**Project
T10/1760-D**

Revision 14
28 January 2008

**Information technology -
Serial Attached SCSI - 2 (SAS-2)**

Summary of Comments on Serial Attached SCSI - 2 (SAS-2) Standard

Figure 9 — State machine conventions

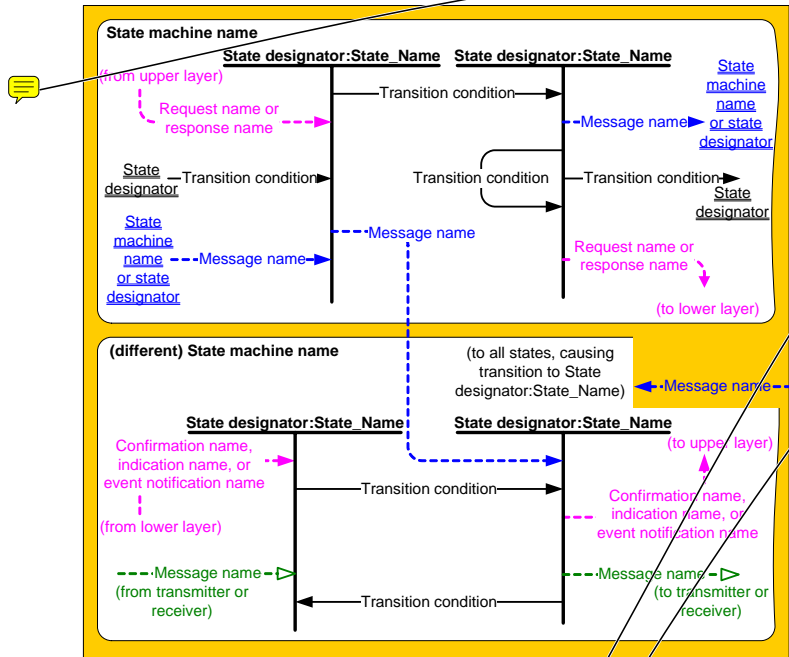
Author: wdc-mevans
Subject: Highlight
Date: 11/6/2008 5:45:04 PM
ACCEPT - DONE (Viso wavy lines - unknown what causes this or what can be done to fix it. Laptop doesn't exhibit the problem.)
Figure 9 — State machine conventions
s/b
[Fix the squiggly lines on the right hand side of both inner boxes in the figure.]

Author: RElliott
Subject: Note
Date: 11/6/2008 5:45:28 PM
ACCEPT - DONE (Viso wavy lines - unknown what causes this or what can be done to fix it. Laptop doesn't exhibit the problem.)
Fix wavy lines

Figure 10 — SAS Domain class diagram

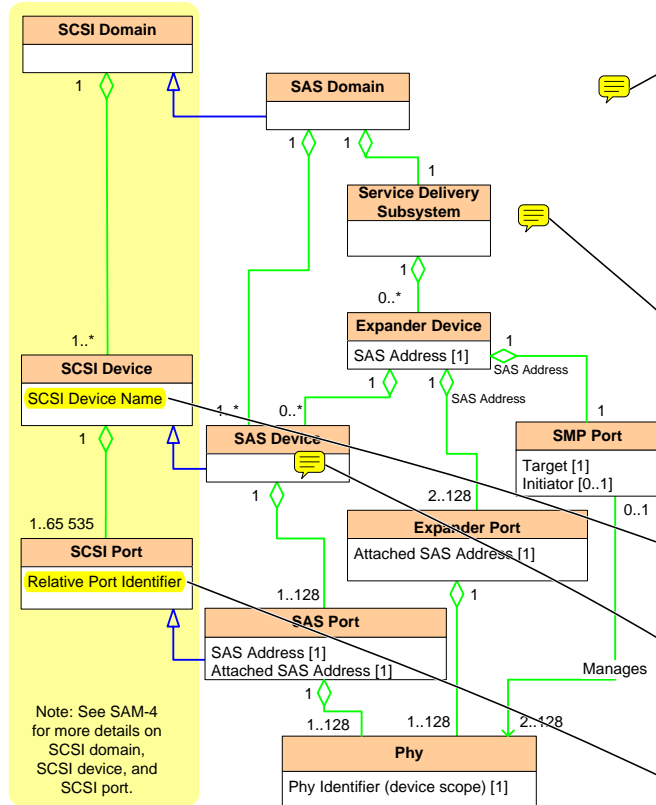
in figure 50, not table 50: 128 to 255, deleted two unnecessary sentences
 I suggest we increase the number of allowed expander phys to 255.

Changes needed:
 Figure 10
 Figure 16
 Section 4.2.8 Phy identifiers shall be greater than or equal to 00h and less than 80h
 Table 8 (7-bit value)
 Table 50

figure 10: changed 1..128 to 1..255
 figure 10: changed 2.. to 2..255

Figure 16 — Port class diagram

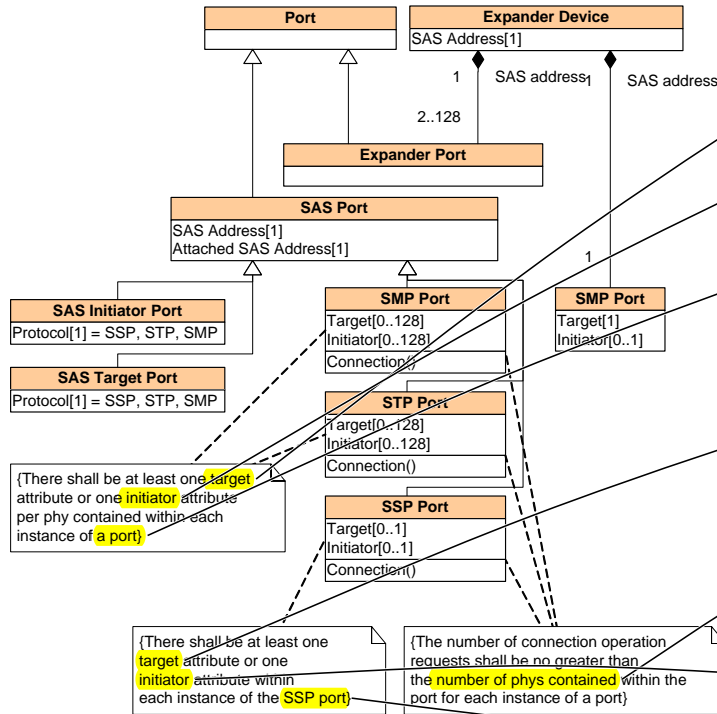
Should be << detail is not shown. However, each port

figure 16: changed [0..128] to [0..255] (zero to 255 possible phys)
 figure 16: changed 2..128 to 2..255

Figure 31 — Transmit data path in a SAS phy

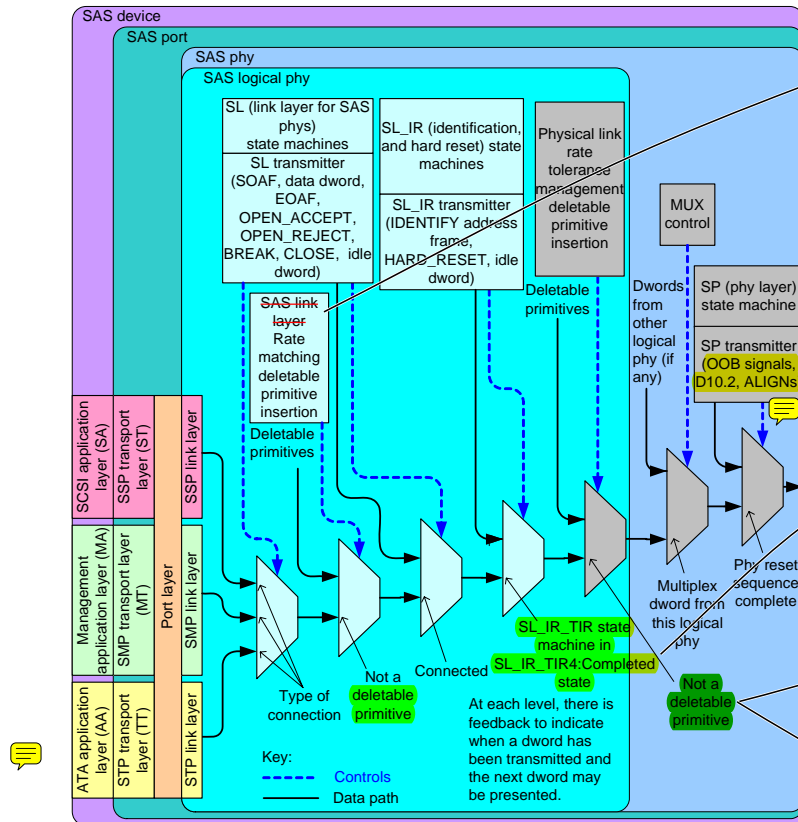
NOTE
 s/b
 Note

Figure 31 — Transmit data path in a SAS phy

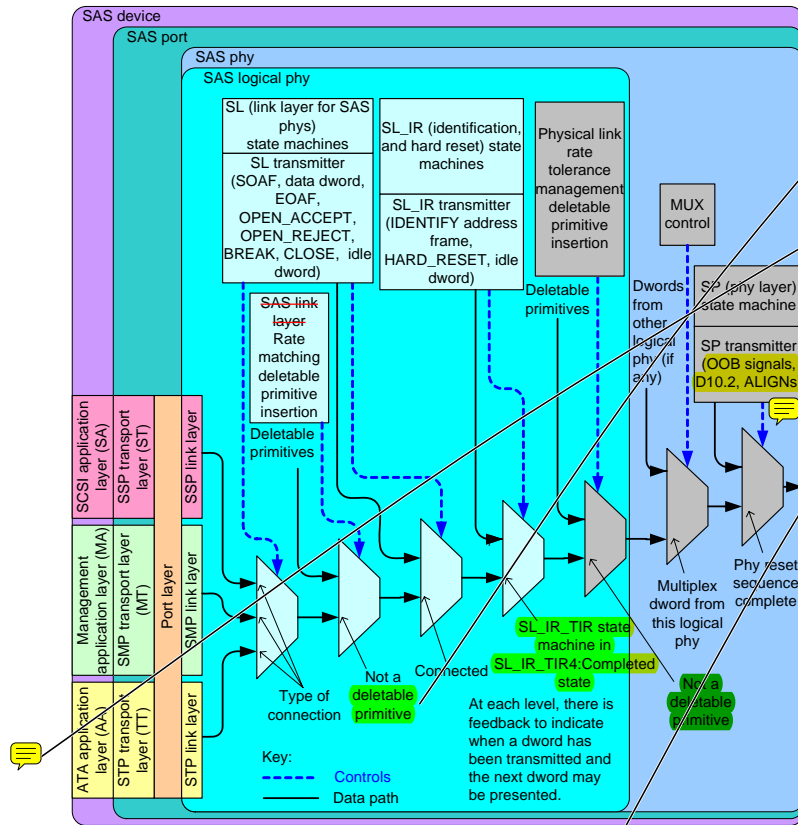
Not a deletable primitive
 3 levels up, the SAS link layer inserts rate matching deletable primitives. Therefore there can be deletable primitives in this path

Add TRAIN pattern and TRAIN_DONE pattern to the list to match into-mseidel comment on figure 31

Figure 36 — Receive data path in a SAS phy

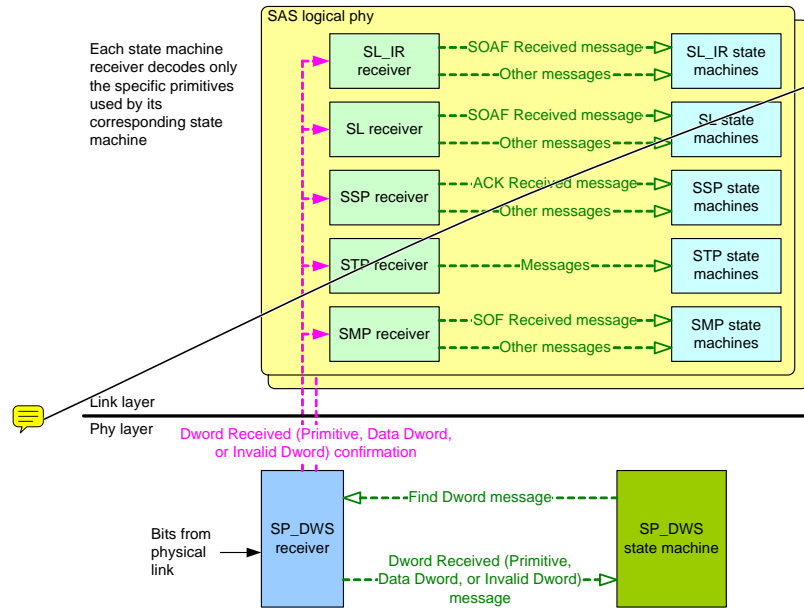
Add messages to figure 35 Receive data path:

Figure 102 — SAS 4i and Mini SAS 4i cable assembly and backplane IT and IR compliance points

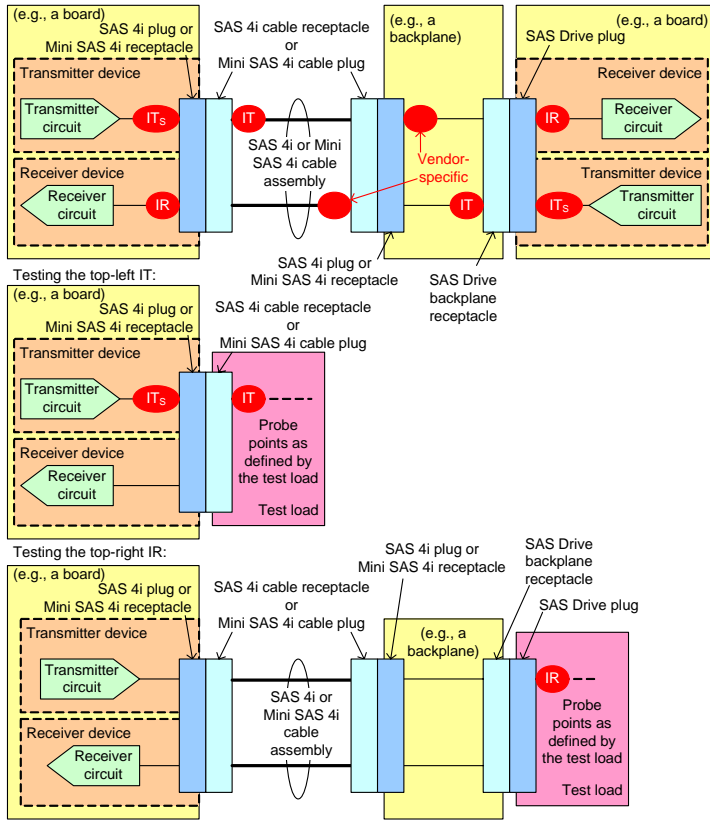
shows how two s/b how sets of two

Figure 134 — SAS bit transmission logic

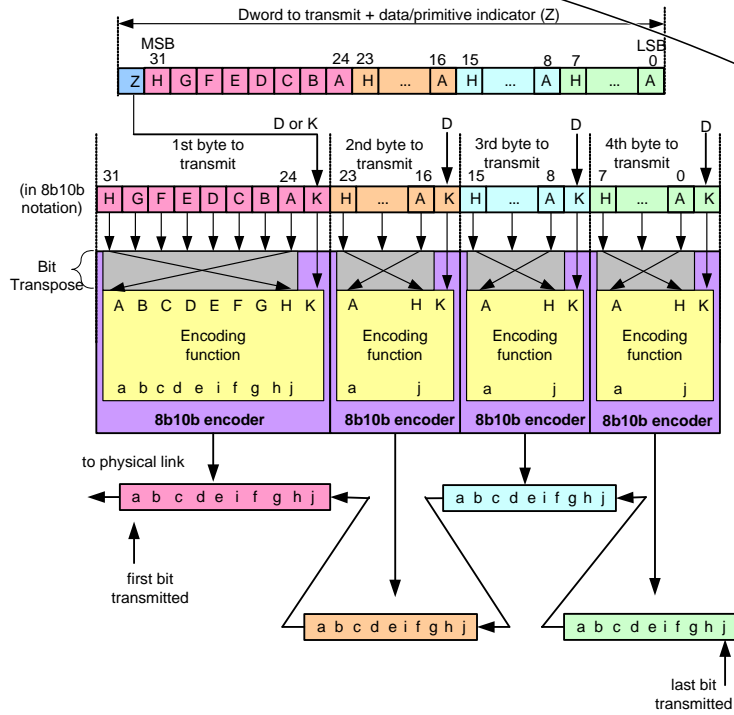
outside of connections
s/b
outside connections
to match other wording

Figure 155 — SP (phy layer) state machine - SAS speed negotiation states

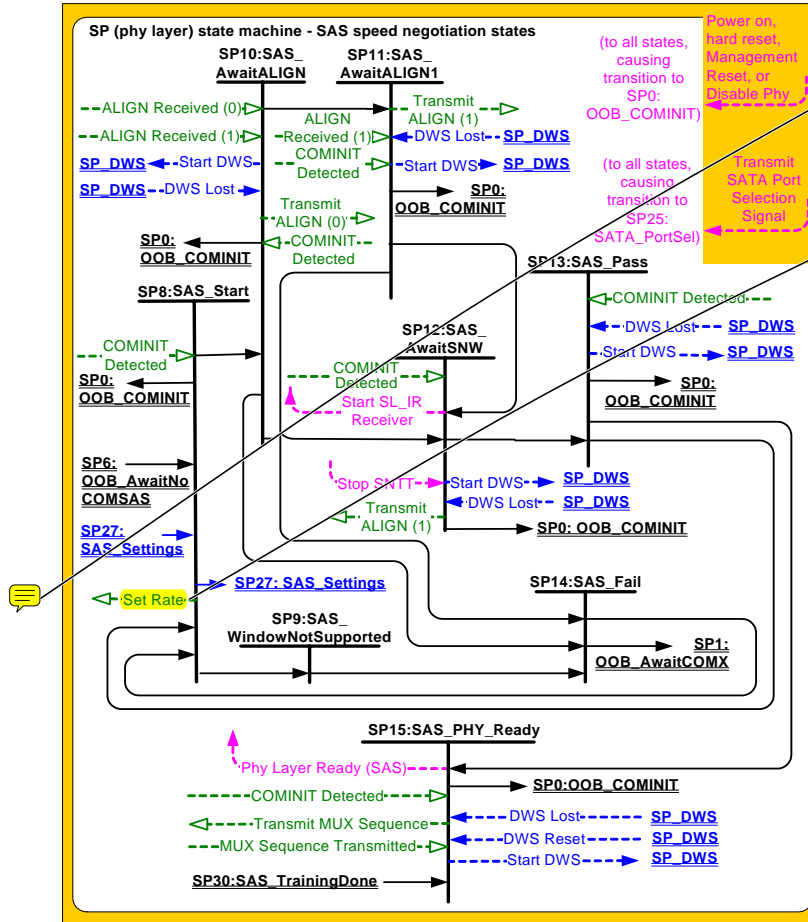
and performs
 s/b
 and the states in the state machine perform

Figure 157 — SP (phy layer) state machine - SATA host emulation states

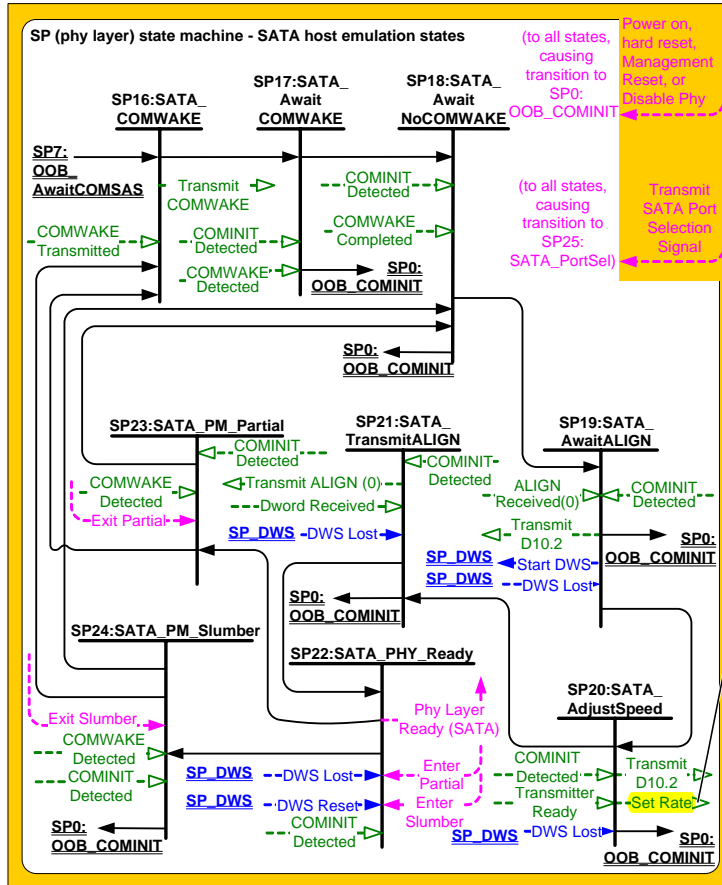
Set Rate
 Change to
 Set Physical Link Rate

Figure 184 — SL (link layer for SAS logical phys) state machines (part 1)

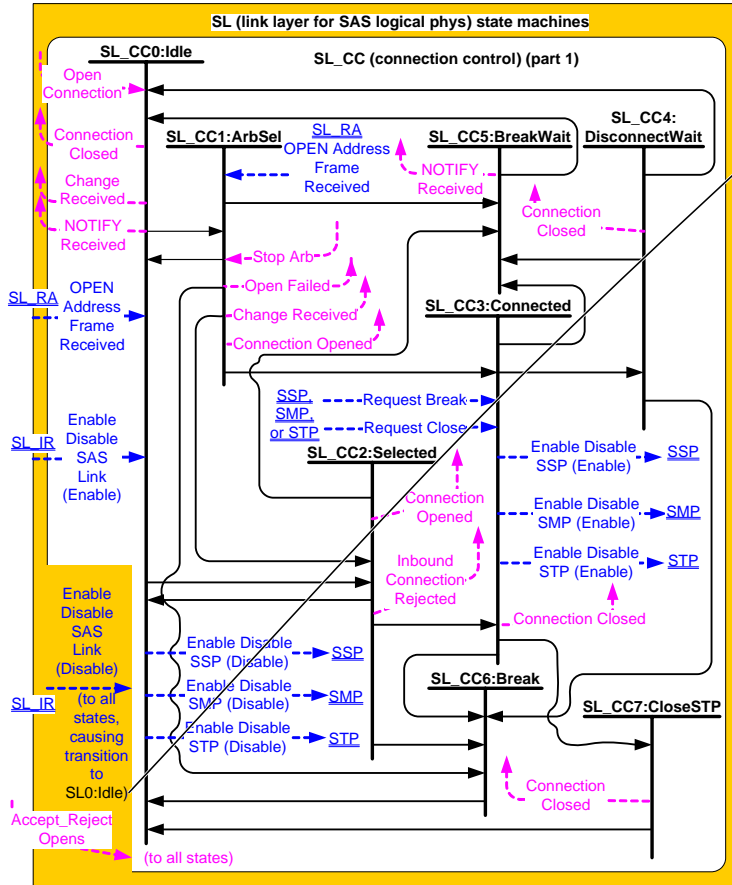
SL0:Idle
 s/b
 SL_CC0:Idle
